An Bord Pleanal
64 Marlborough Street
Dublin 1
D01 V902

10 September 2020

Construction of the Boyne Greenway Drogheda to Mornington, Co. Meath & Co. Louth (APB-307652-20)

(Extract of map taken from SI 626/2011 showing SPA starts at centre of R150 road and goes North to the Boyne River)

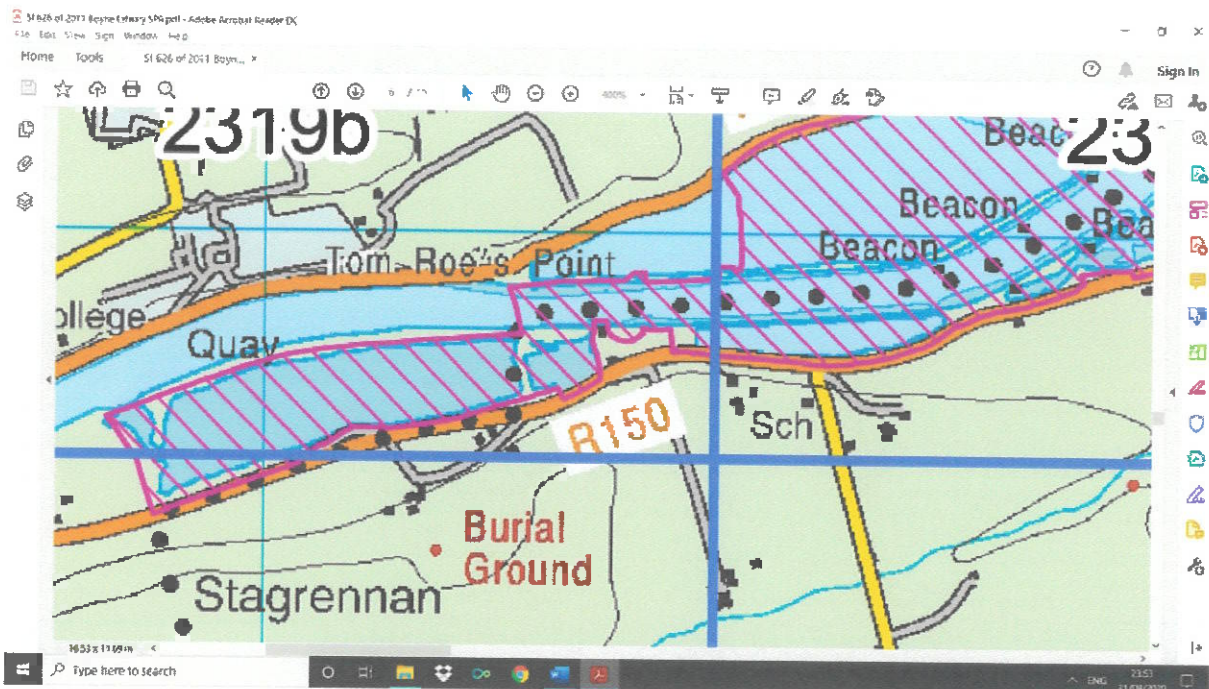
8. The outline of the SPA, as contained in Statutory Instrument No. 626 of 2011 (Ref. Q., available from www.npws.ie), runs from the centre of the road R150 at the Meath/Louth county boundary at Stagrennan to North across the River Boyne Estuary that means any construction on the riverside of the northern edge of the R150 road (apart from private property) encroaches the SPA and/or the SAC.
